UNITED STATES ENVIRONMENTAL PROTECTION AGENCY
REGION 4
ATLANTA FEDERAL CENTER
61 FORSYTH STREET
ATLANTA, GEORGIA 30303-8960

This letter is in response to your request for concurrence on the proposed disposal of maintenance dredged material from the Jacksonville Harbor Deepening and Widening Project into the Jacksonville Ocean Dredged Material Disposal Site (ODMDS).

Figure 1. Jacksonville ODMDS Location Map and Disposal Release Zones (From: Jacksonville ODMDS Site Management and Monitoring Plan, 2015)

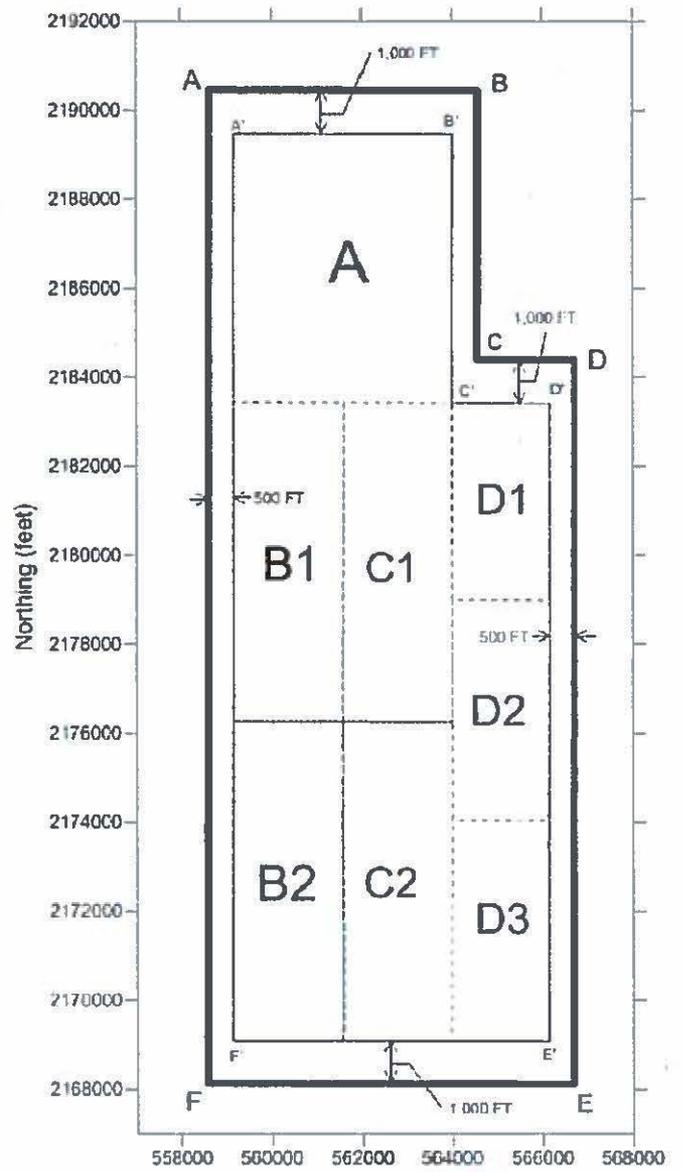
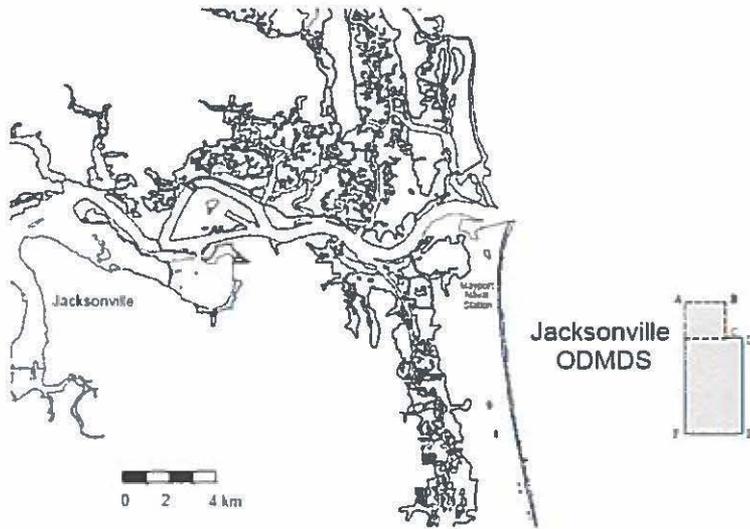
Our concurrence on the disposal of this material is contingent upon compliance with all specifications and conditions of the Jacksonville ODMDS Site Management and Monitoring Plan. Specifically, all disposals will be initiated at least 500 feet from the east and west boundaries and 1000 feet from the north and south boundaries of the ODMDS. Disposal will be completed (i.e. doors closed) prior to leaving the ODMDS boundaries. Disposal shall occur in one of the release zones based on sediment type as described in Table 1 and shown in Figure 1 (enclosed). As described in Table 1, all material from each dredging unit shall be placed into the first designated disposal zone for that unit up to the depth specified in the second column ("Dredging Depth"). Any material removed after this depth to the proposed project depth (including overdredge and advanced maintenance material) shall be placed into the second disposal zone specified for that dredging unit.
